File Ref: PZ/VL/P21-2319/03TN

Subject: Potters Farm – Deadline 6 Noise

- 1.1 Create Consulting Engineers Ltd (Create) have been appointed by our Client (LJ & EL Dowley) to provide a written submission for “Deadline 6” in line with the Planning Inspectorate timescale for Potters Farm.

**THEBERTON HOUSE ESTATE, SIZEWELL C – Potters Farm
Construction Noise Assessment**

Figure 5.1: ES Measurement Location MS4

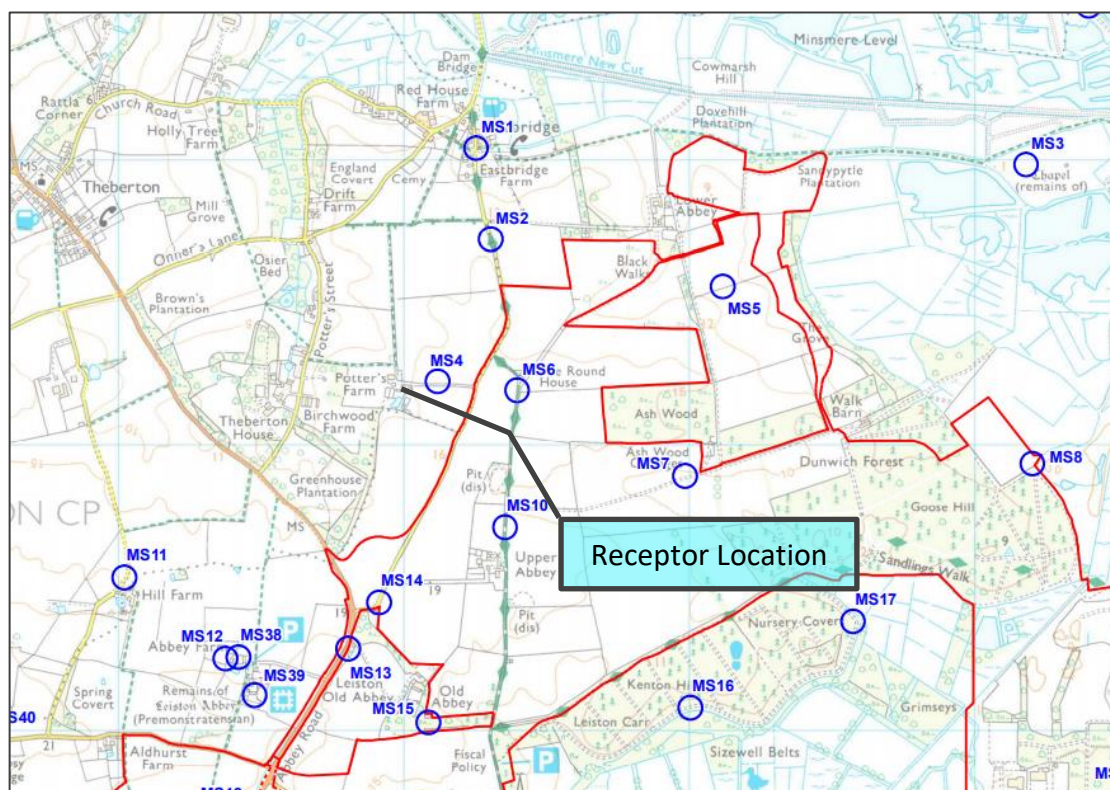
- 5.4 The most representative monitor location in the EDF ES for the Potters Farm Residence NSR would be MS4, which was stated to be a typical measured daytime level of around 43 dB $L_{Aeq,T}$. (Book 6.3, Chapter 11, Construction Noise and Vibration Appendix 11B).
- 5.5 Within the submitted document, the baseline sound levels were largely similar to those from the Create baseline sound monitoring for the daytime ambient sound level, differing by only 2 dB.
- 5.6 The stated measurement duration at MS4 was between the 11th – 14th and 19th – 23rd September 2016 (Page 37, Book 6.3, Volume 2, Chapter 11 Appendix 11A).

Figure 6.1: Phase 1a: No Mitigation *Left* & Phase 1a: With Mitigation *Right*

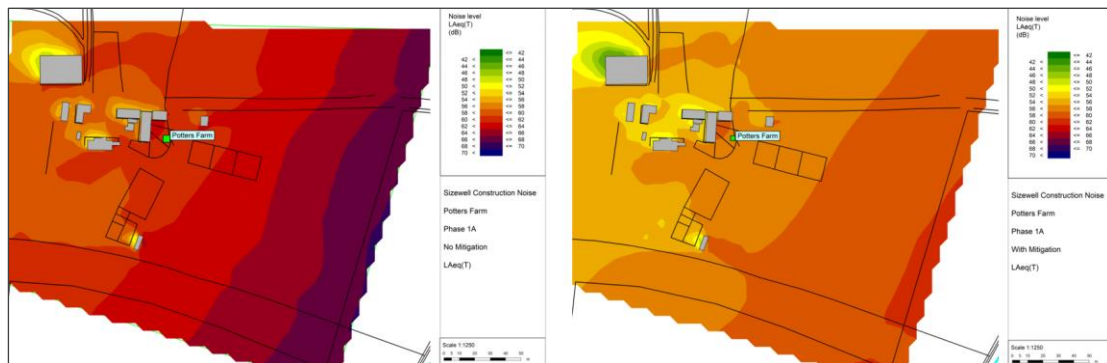
- 6.18 It can be seen in the figures above that in all instances (both with and without mitigation), the predicted ambient would exceed the residual ambient measured. Given the works duration of >4 years, this change would be regarded as considerable.
- 6.19 Table 11.32 in Book 6, Volume 2, Chapter 11 defines the residual effects following mitigation at the various receptors around the site, for which receptor 17 is Potters Farm. The following table shows the assessment of effects following primary, tertiary and additional mitigation measures during the works phases 1a and 1b:
